# Access Compliance Report

### (Curb Ramps)

Intersection ID: 42927	Main Street: BRAY_DR	Cross Street: FOYNES_CT	Location: SE
ADA ID: 100033CFFA99	Ramp Type: PerpDiag	Initial Pass/Fail: Fail	Overall Compliance: No
			Severity Score: 46.25

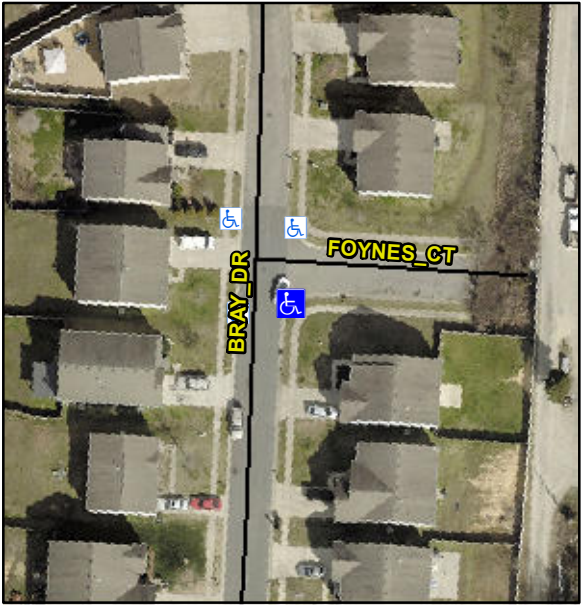
Codes/Mitigation Info/Possible Solution			Field Measurements/Component Compliance			
	Possible Solutions:		<b>Compliance</b>	<b>Description</b>	<b>Data</b>	
	<b>Remove &amp; Replace Curb Ramp With Two New Directional Ramps or Equivalent.</b>		N/A	Ramp Length (in)	47.0	No
			No	Ramp Width (in)	40.0	No
			N/A	Flare Type LT	N/A	N/A
			N/A	Flare Slope LT (%)	N/A	N/A
			N/A	Flare Traversable LT?	N/A	N/A
			N/A	Landing Length (in)	N/A	N/A
			N/A	Landing Width (in)	N/A	N/A
			N/A	Landing Slope (%)	N/A	N/A
			N/A	Landing X Slope (%)	N/A	N/A
			N/A	Landing Curb? (Y/N)	N/A	N/A
			N/A	Shared Landing?	N/A	
			N/A	Gutter Ponding?	N/A	N/A
			N/A	Gutter Lip Ht (in)	N/A	N/A
			N/A	Painted X Walk1?	No	N/A
				X Walk 1 Direction	To N	To W
			N/A	X Walk 1 Width (in)	N/A	N/A
				X Walk 1 Slope (%)	3.6	X Walk 2 Slope (%)
				X Walk 1 X Slope (%)	0.6	X Walk 2 X Slope (%)
			N/A	Ramp inside XWalk1?	N/A	N/A
<p>Surveyor Notes:</p> <p>N/A</p>				Road Slope (%)	1.4	N/A

Road X Slope (%)	0.8	N/A
<p>PROW/ADA:</p> <p><b>Not Found, R304.5.1, R304.2.2, R304.5.3</b></p>			N/A	Any Obstructions?	N/A	N/A
				Obstruction Type		
Total Cost:		\$ 3200.00				
					N/A	N/A
					Yes	Surface Condition? (G/P) Good
